AGENDA PORTLAND PLANNING BOARD MEETING

Level III Site Plan Review

Submitted to: Portland Planning Board
Public Hearing Date: April 28, 2020

Overview: This memo has been prepared in response to comments received from your office dated January 21, 2020 and amended on February 3, 2020. The responses follow the order in which that were written and will identify the reviewer and overall topic reviewed as well as a brief summary of the question with an answer to follow.

C-101

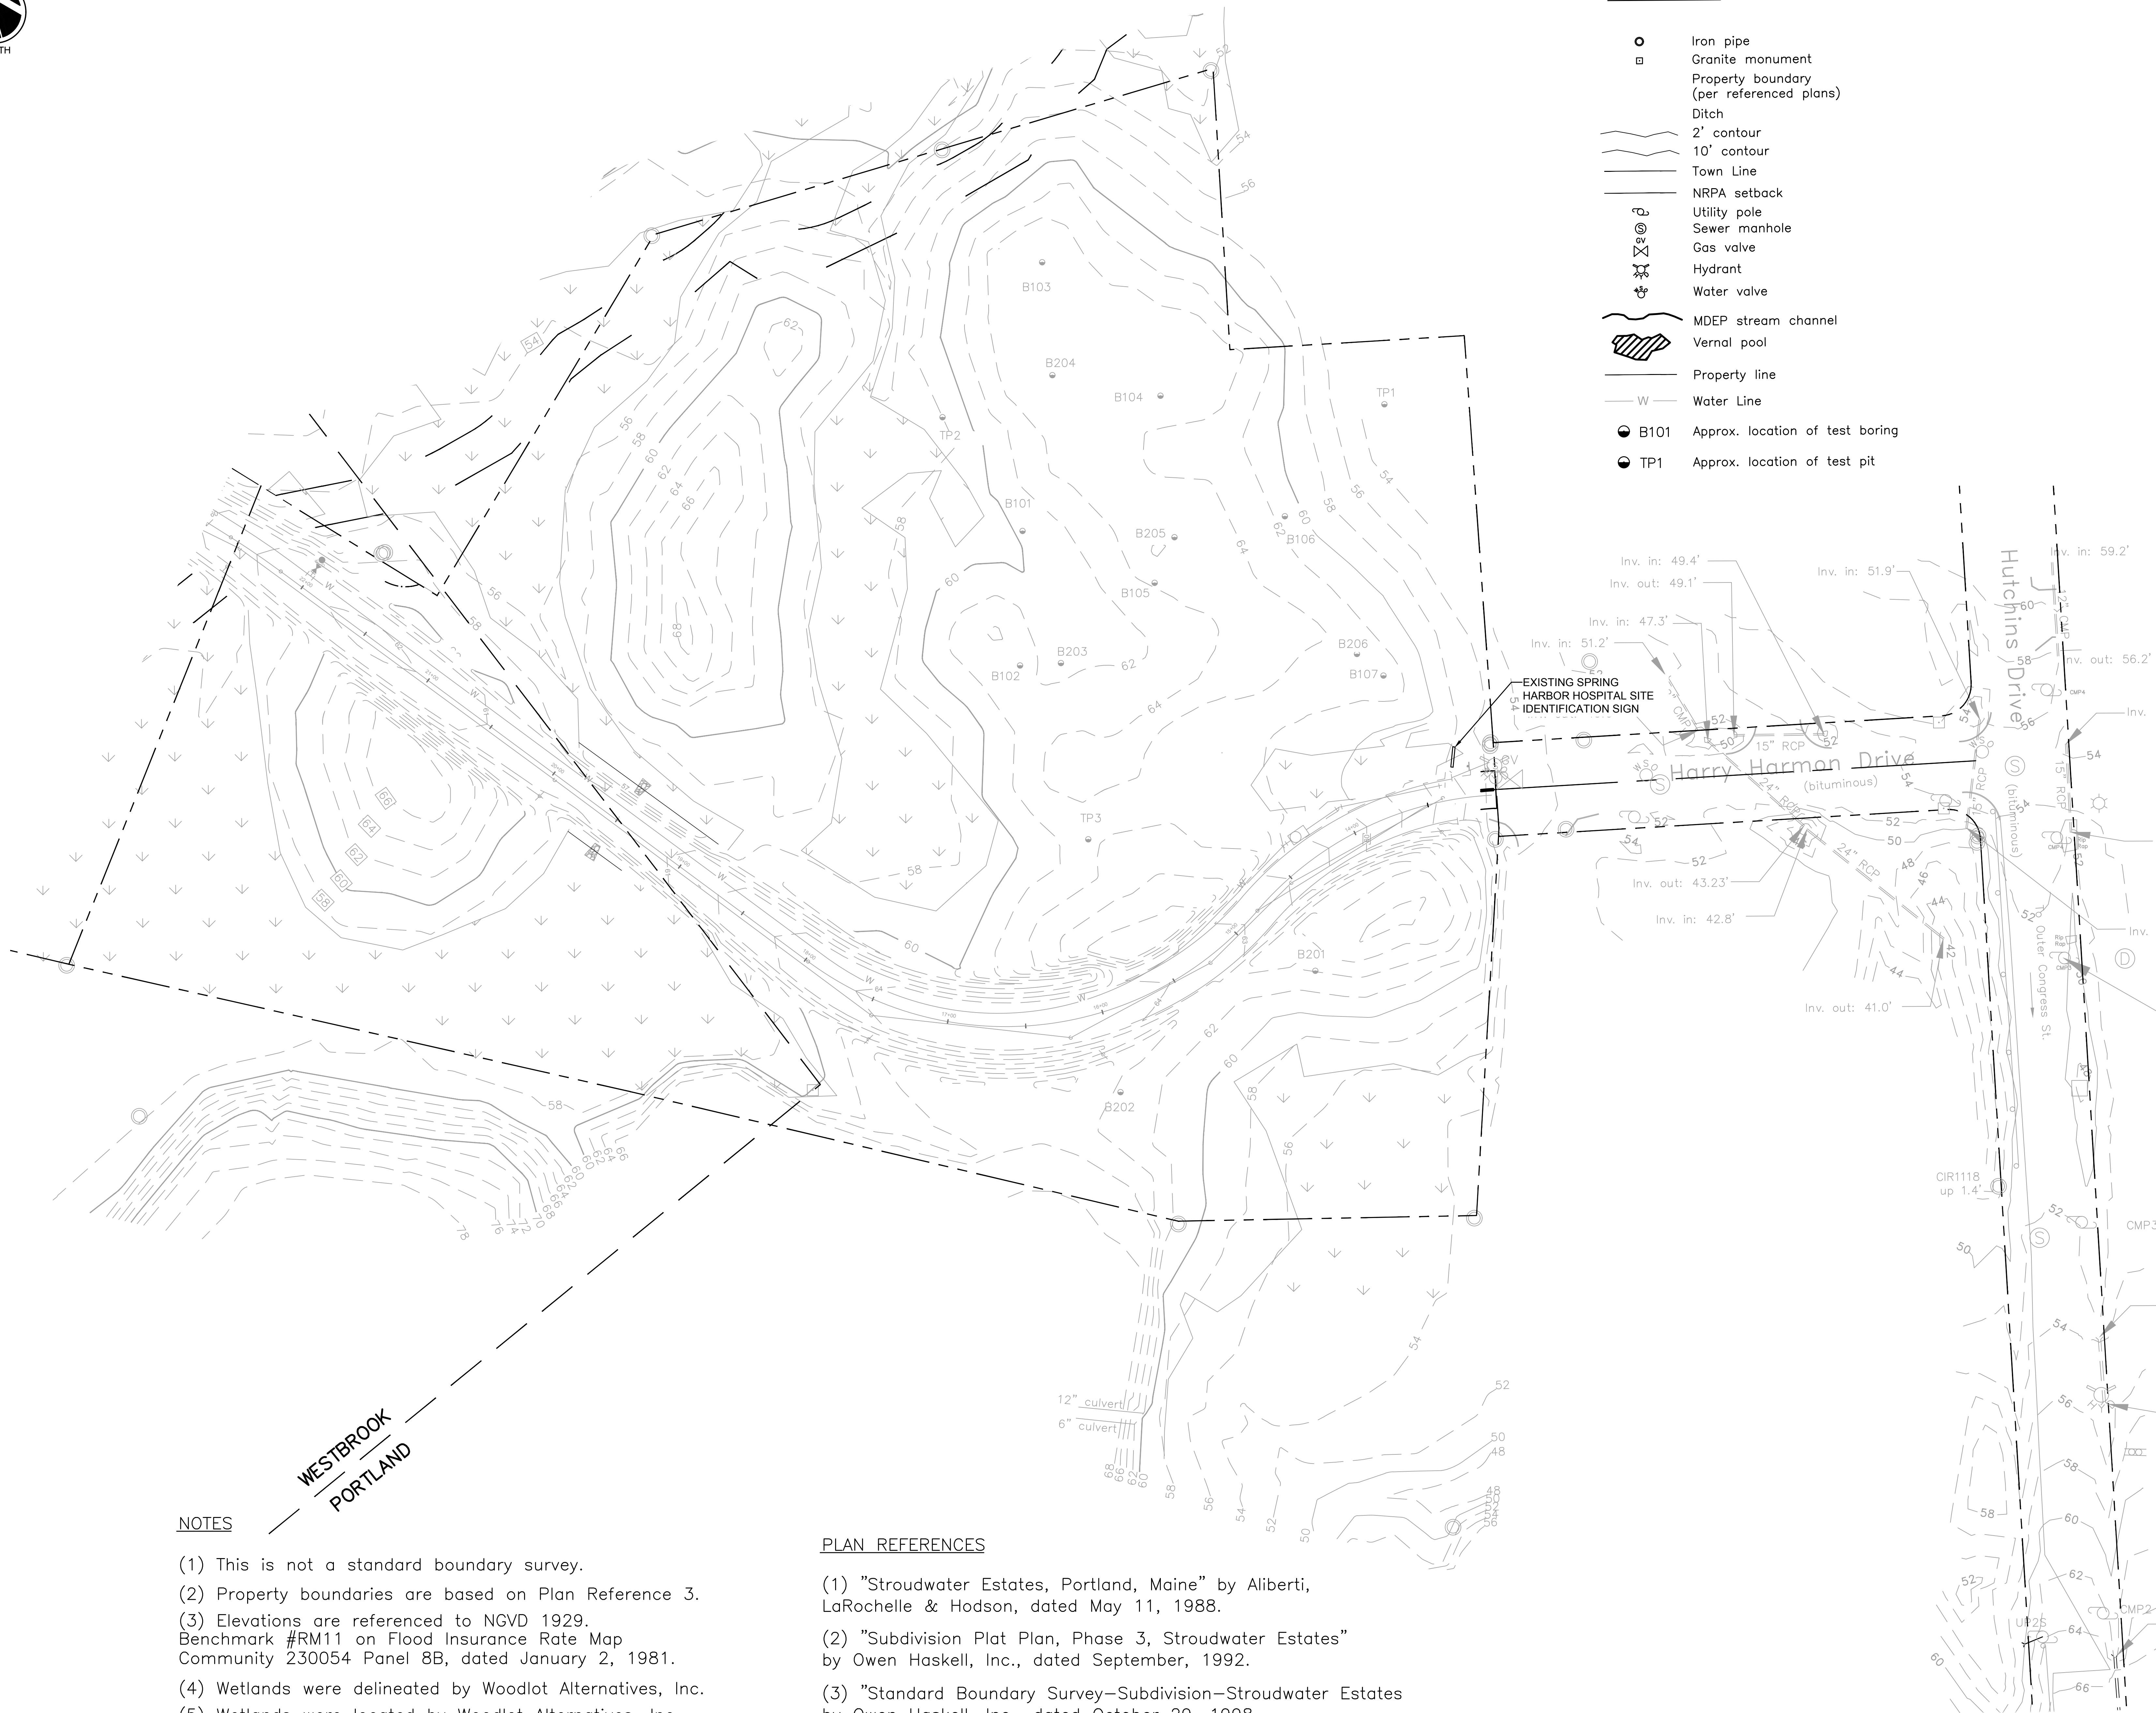
Snow Storage: Snow storage is not intended to be placed in a wetland and the outline of the snow storage areas on drawing C-101 will be revised so that it does not overlap the wetland edge. We also encourage limited use of salt and anticipate it primarily being used in the sidewalk areas.

Building Footprint: These issues have been addressed and the revisions are reflected on drawing C-101 on the January 22, 2020 submission.

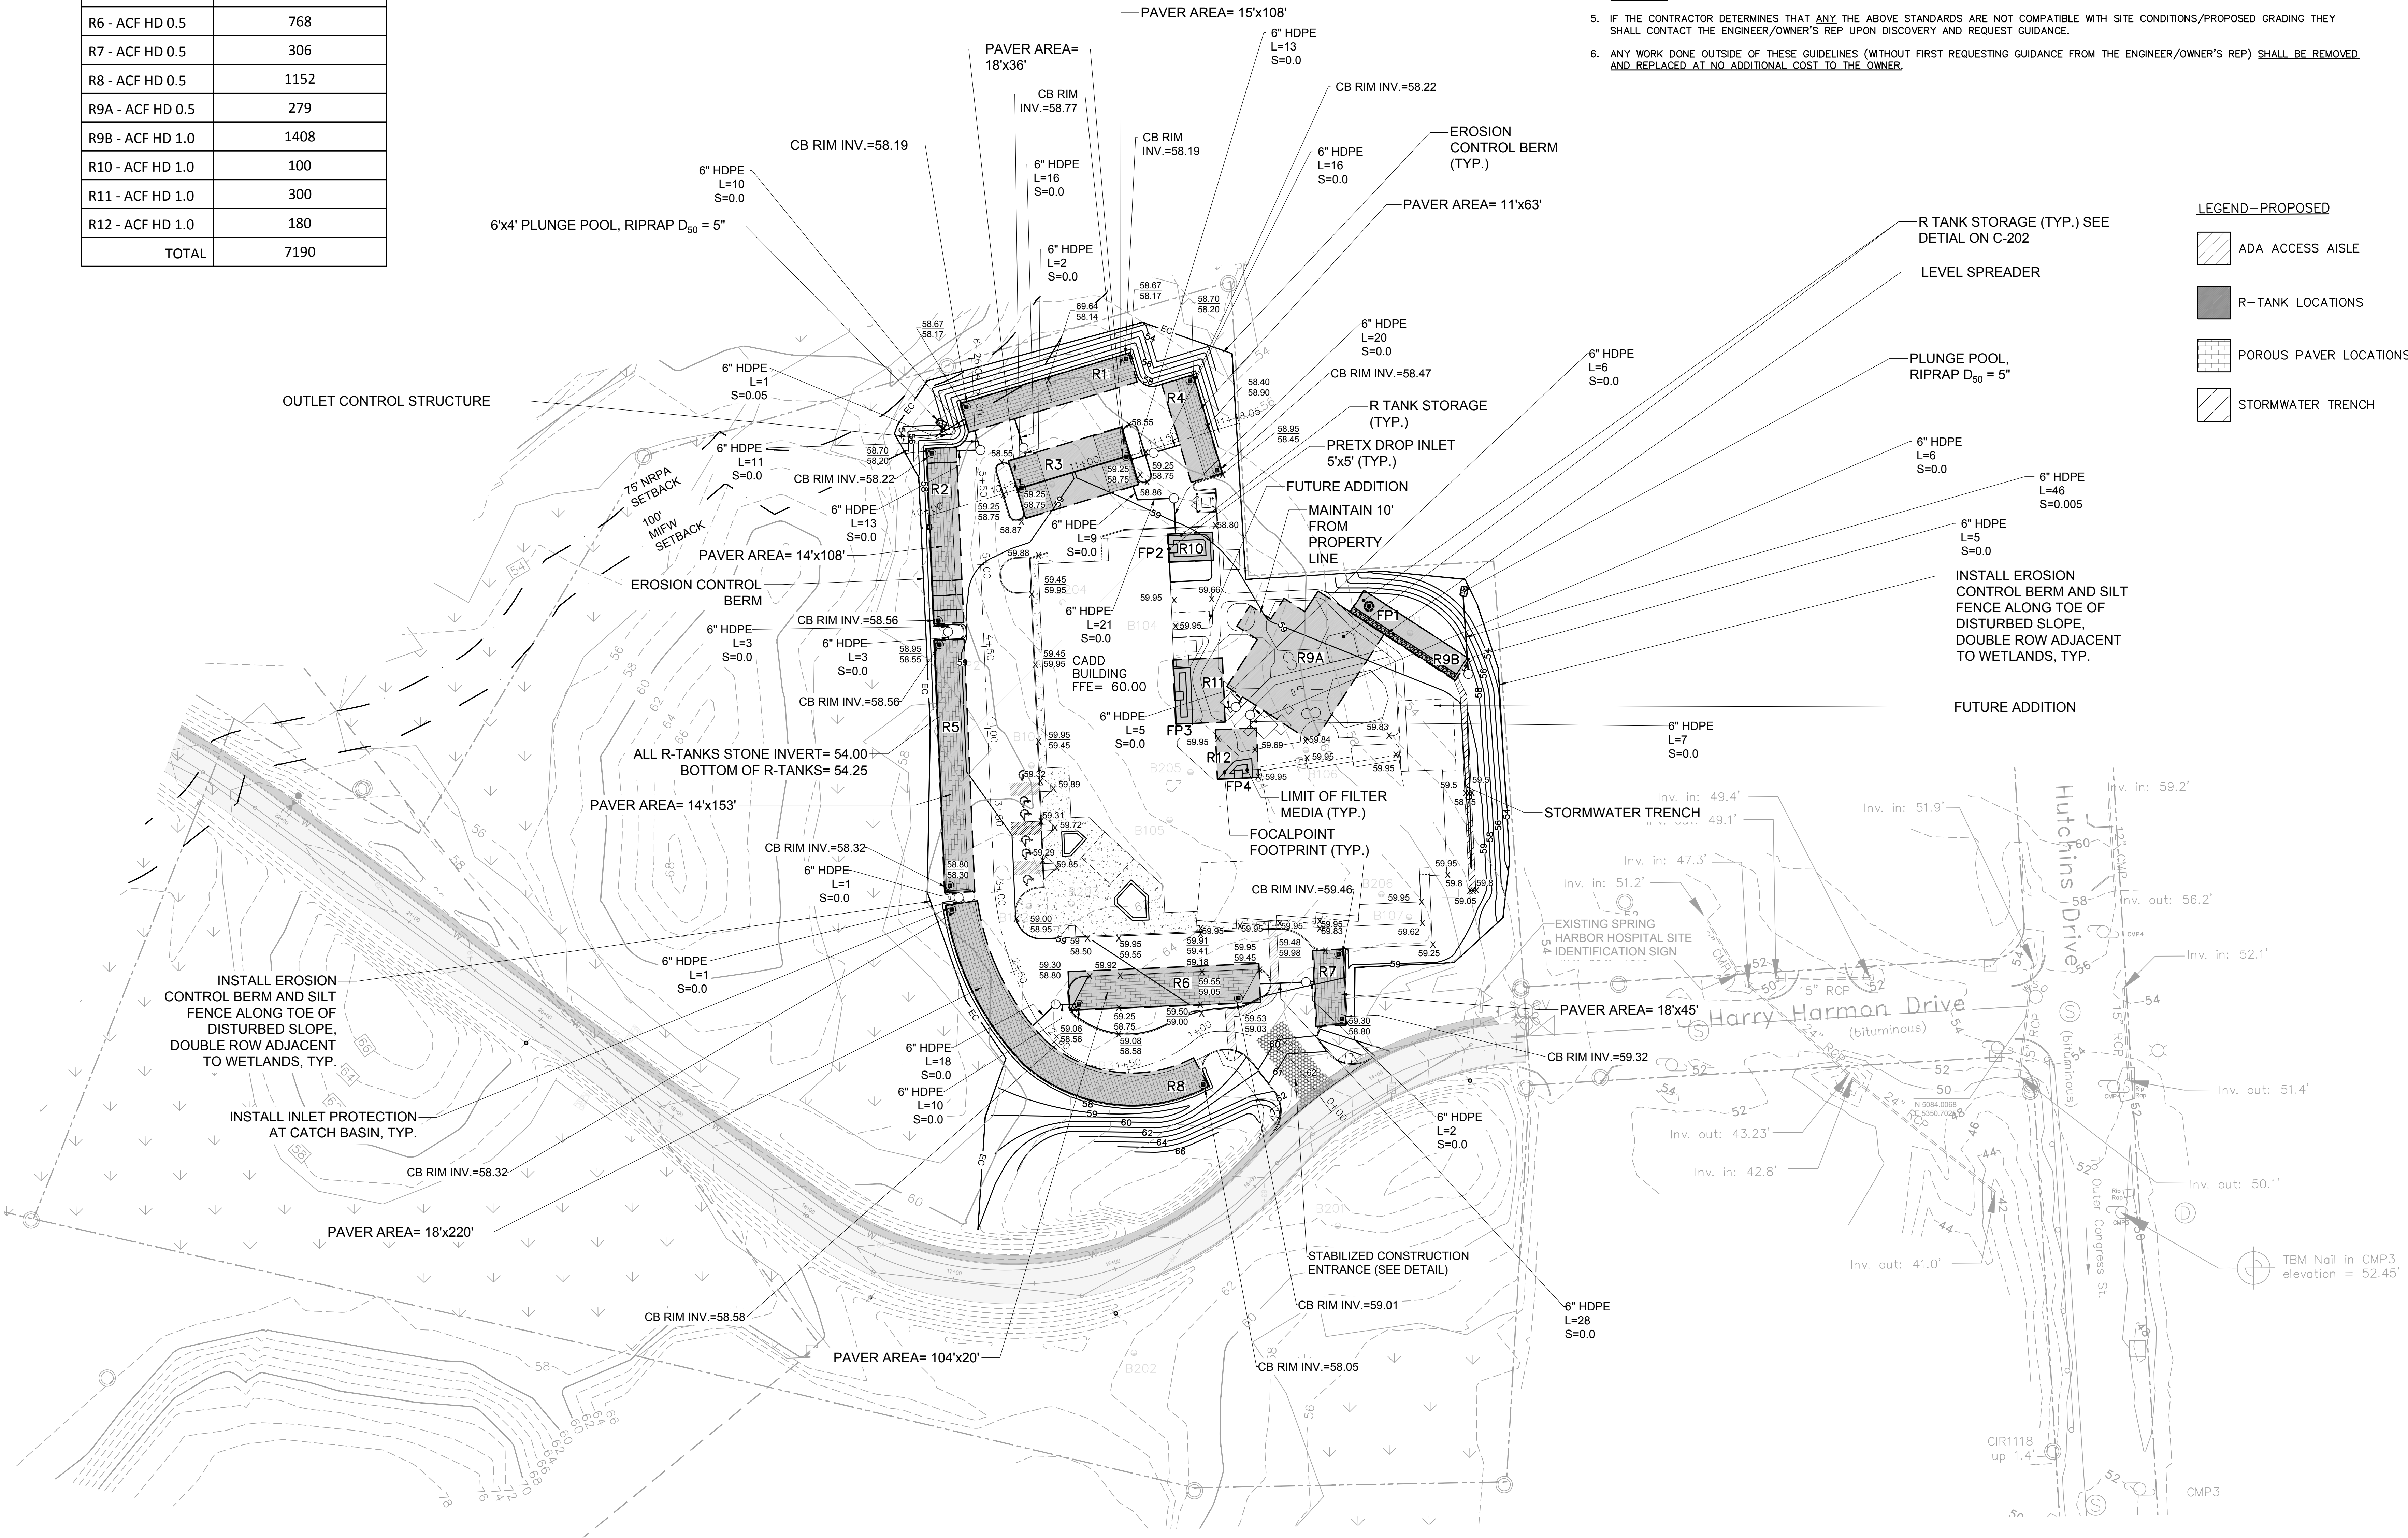
Diagonal Parking Spot Grades/ Drainage: See revised C-102 drawing submitted revised on the January 22, 2020.

Grading/ Drainage structures: These issues have been addressed and the revisions are reflected on drawing C-102 on the January 22, 2020 submission.

Basic Standards: We will show the construction entrance on the Grading and Drainage plan in the next drawing submission.

General Standards: These issues have been addressed and the revisions are reflected on drawing C-102 on the January 22, 2020 submission.
